Subject: Duke Energy Carolinas, LLC
William States Lee III Nuclear Station – Docket Nos. 52-018 and 52-019
AP1000 Combined License Application for the
William States Lee III Nuclear Station Units 1 and 2
Response to Request for Additional Information (eRAI 6497)
Ltr# WLG2012.06-07

Lee Nuclear Station Response to Request for Additional Information (RAI)

RAI Letter No. 106

Conceptual MSE Wall Fill Material and Design

Figure 1, SCDOT 305.2.5.5 Macadam Base Course Gradation Limits

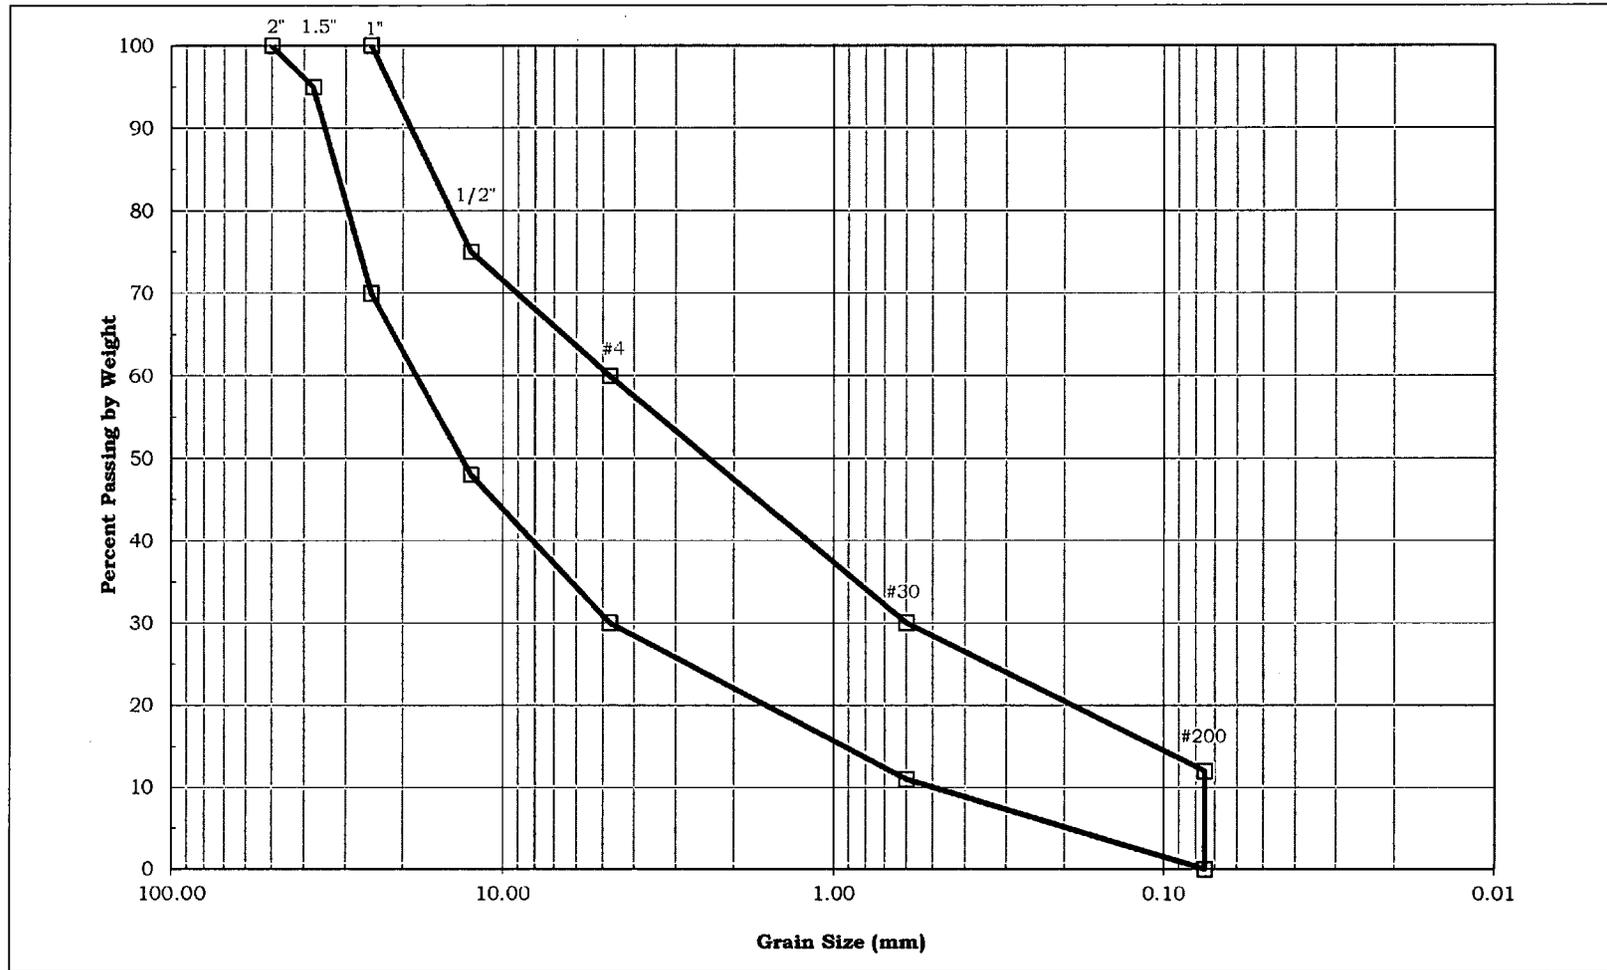
To address these issues and to ensure compliance with 10 CFR 100.23 and 10 CFR Part 50, Appendix S, please: 1) specify the type of soil to be used as backfill material with its classification and static and dynamic properties; 2) discuss how to ensure that as-placed backfill properties are comparable to those assumed in site-specific analyses; 3) provide details of MSE wall design; and 4) discuss its impact on side fill compaction and structural stability analyses so that the staff can conduct a full evaluation of foundations/structures stability.

As stated in FSAR Subsection 2.5.4.5.3.5, Granular Backfill Outside the Nuclear Island, these granular materials will meet the gradation requirements for Macadam Base Course, defined in Subsection 305.2.5.5 of the South Carolina Department of Transportation (SCDOT) Standard Specifications for Highway Construction, and Washed Screenings, defined in Subsection 408.2.2. The Macadam Base Course materials are also expected to meet the plasticity limits specified in Section 305.2.5.5 of the SCDOT specifications. Thus, these granular fill materials will consist of granular soils (gravels and sands) having limited amounts of fines (i.e., no more than 12 percent), a maximum liquid limit of 25, and a maximum plasticity index of 6.

The upper- and lower-bound gradation limits of the Macadam Base Course are shown on Figure 1.
